Before the Independent Commissioners of the Northland Regional Council (NRC)

In the Matter of applications by members of the Aupōuri Aquifer Water Users
Group for 24 new groundwater takes from the Aupōuri Aquifer
subzones: Other, Waihopo, Houhora, Motutangi, Waiparera,
Paparore, Sweetwater

Statement of Evidence of

For the Ministry of Education

Figure 2: Monitoring and production bore location map for the Northern sub-region (with school locations marked by red triangles. Map modified from GMCP for the northern sub-area (July 2020).

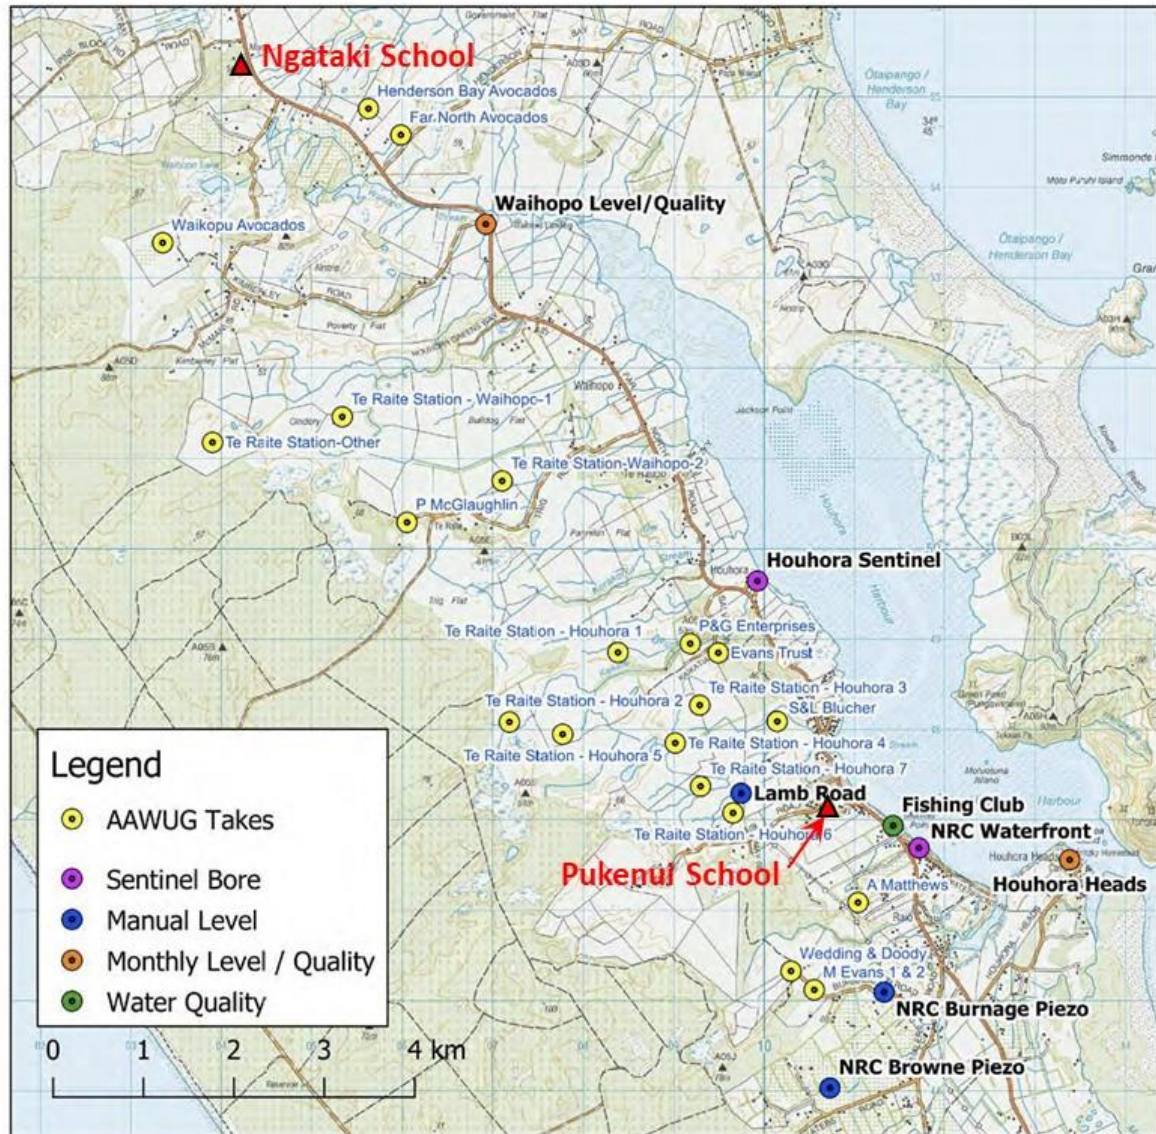
- 4.8** **Ngataki School** has an 18-m deep bore screened in the shallow aquifer. The nearest proposed applicant abstraction bores are Henderson Bay Avocados, located about 1.4 km to the east of the school and Far North Avocados, located about 1.9 km to the east of the school (Figure 2). Proposed monitoring bore "Waihopo Level/Quality" is tentatively planned to be located about 3 km from the school. According to the proposed GMCP, this bore will be completed in the deeper shell bed aquifer and monitored monthly for water levels and quarterly for salinity indicators (electrical conductivity). The proposed production bores will be completed in the deeper shell bed aquifer and monitored monthly. However, there are no nearby shallow bores proposed in the GMCP to monitor groundwater levels in the shallow aquifer near Ngataki School. I consider that monitoring of the shallow aquifer is also required to confirm that it is not affected by abstraction from the deeper shell bed aquifer at the applicant's proposed bore locations.

4.9 Pukenui School has a 30-m deep bore screened in the shallow aquifer. The school is approximately equidistant (about 1 km) from three proposed applicant abstraction bores (all from the deeper shell bed aquifer): S&L Blucher, Te Raite Station, and A Matthews (Figure 2). An existing monitoring bore in the deeper shell bed aquifer, named “Fishing Club”, is located about 0.7 km to the east of the school. Two proposed monitoring bores (shallow aquifer and deeper shell bed aquifer) are planned for “Lamb Road”, approximately 1 km to the west. In addition, there are two proposed sentinel bores (“NRC Waterfront”) located about 1 km to the east. I concur that the proposed monitoring requirements outlined in the GMCP for the shallow and deep sentinel bores (“NRC Waterfront”) will provide sufficient monitoring of the shallow groundwater levels and saline intrusion risk for the Pukenui School bore.

- 5.1 Ngataki School** – Because the school bore is located within 2 km of two proposed abstraction bores, and there are no shallow monitoring bores nearby, I recommend that the Ngataki School shallow bore be included in the proposed GMCP for the northern sub-region as one of the scheduled monitoring bores requiring monthly monitoring of water levels and quarterly monitoring of salinity indicators (electrical conductivity).

Figure 3: Monitoring and production bore location map for the Middle sub-region (with school locations marked by red triangles). Map modified from GMCP for the middle sub-area (July 2020).

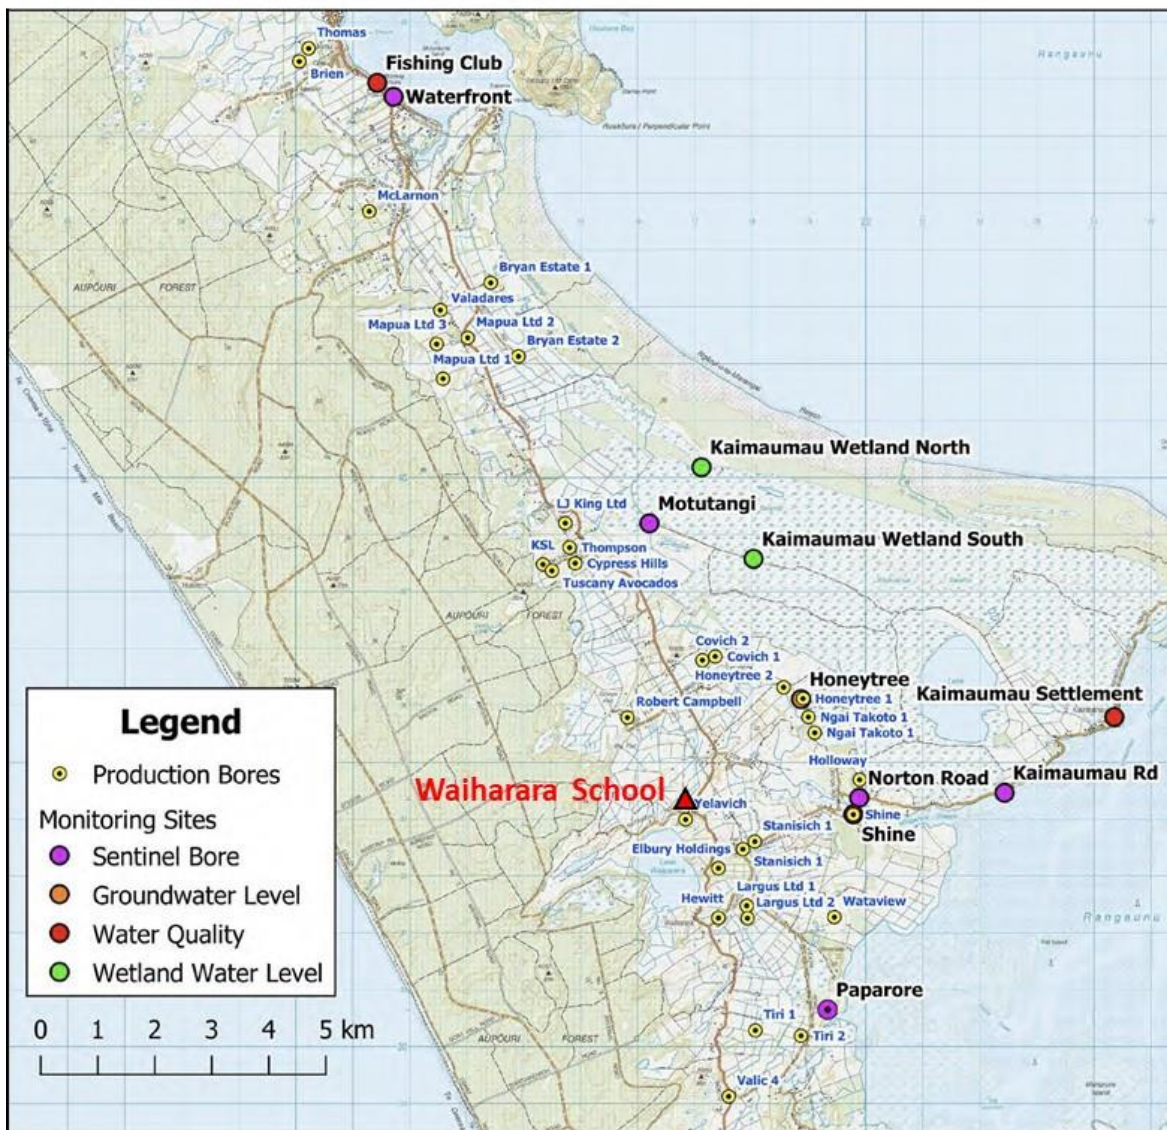
4.10 Waiharara School has a 38-m deep bore screened in the shallow aquifer. The nearest proposed applicant abstraction bore is Mate Yelavich & Co, located about 0.2 km to the south (Figure 3). The nearest proposed monitoring bore is “Norton Road”, a new sentinel bore tentatively located about 3 km to the east and completed in the deeper shell bed aquifer. Other nearby sentinel bores (Kaimaumau Rd and Paparore) will be completed in both the shallow and deeper shell bed aquifers. These sentinel bores are sufficient to monitor for saline intrusion. However, there are no nearby shallow bores proposed in the GMCP to

monitor groundwater levels in the shallow aquifer near Waiharara School. I consider that monitoring of the shallow aquifer, closer to the production bore, is warranted to confirm that it is not affected by abstraction from the deeper shell bed aquifer at the proposed Yelavich bore, located about 200 m (and perhaps less) across Katavich Road.

- 5.2 Waiharara School** – Because the school bore is located only about 200 m (or closer) from the proposed Yelavich abstraction bore, and there are no shallow monitoring bores nearby, I recommend that the Waiharara School shallow bore be included in the proposed GMCP for the middle sub-region as one of the scheduled monitoring bores requiring monthly monitoring of water levels and quarterly monitoring of salinity indicators (electrical conductivity).
